E4428C-09

S E R V I C E N O T E

E4428C Signal Generator

Power supply replacement for customer satisfaction purposes.

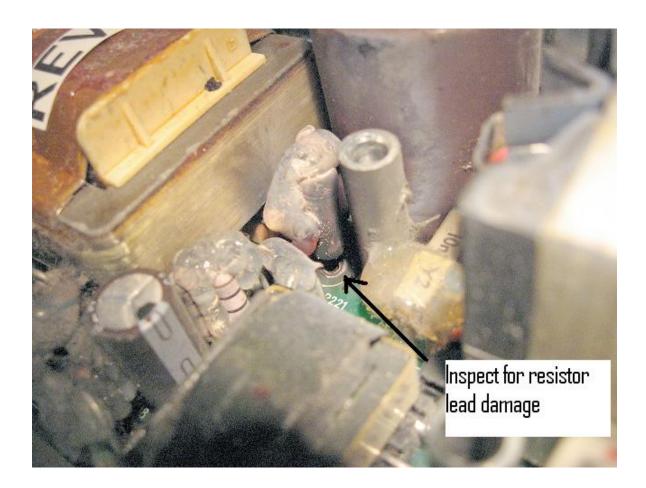
An increasing failure rate of 0950-4031 Rev B/C power supplies has been observed. For customer satisfaction failed 0950-4031 Rev B/C power supplies is authorized. 0950-4031 Rev D power supplies may be used until gone and then 0950-5037 may be used.

Additionally the condition of the solder on the reverse side of working power supplies is to be inspected and the power supply replaced if the solder is found to be deteriorated.

1. ON SPECIFIC FAILURE: Replace failed 0950-4031 Rev B/C power supplies with 0950-4031 Rev D power supplies or, 0950-5037 power supplies after stock of 0950-4031 is gone, in cases where lead failure of R6 or R9 as shown in the photograph below. Other failures are not covered by this Service Note.

2. ON CONTACT INSPECTION: Inspect the condition of solder on the reverse side of working power supplies, in location shown in the photos below (R6/R9). If the solder is found to be deteriorated, appearing granular or partially re-melted, as shown in the picture on the right below, replace the power supply. It is normal for the solder mask to have changed color from green to grey/brown on the trace between the connections to be inspected.
